# Product Change Notification

## 111583 - 00

**Change Notification #:** 111583 - 00  
**Change Title:** Intel® Server System SC5650HCBRPR  
PCN 111583-00, Product Material  
Updating the CPU Protective Cover  
**Date of Publication:** July 2, 2012

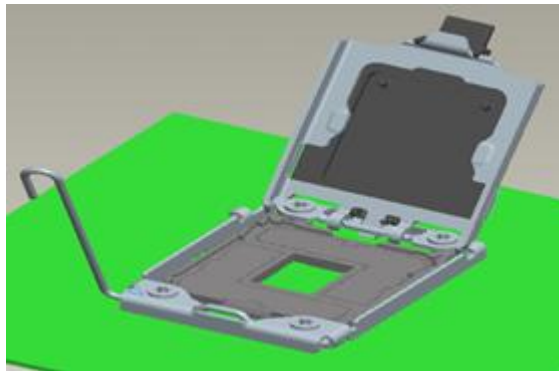
- Update the CPU protective cover to reduce the possibility of pin damage during processor installation.
- Below is a picture of the new protective plate cover:

The CPU socket protective cover change has no functional impact but may require a process change when inserting a CPU into the server board, so manufacturing documentation may need to be updated.
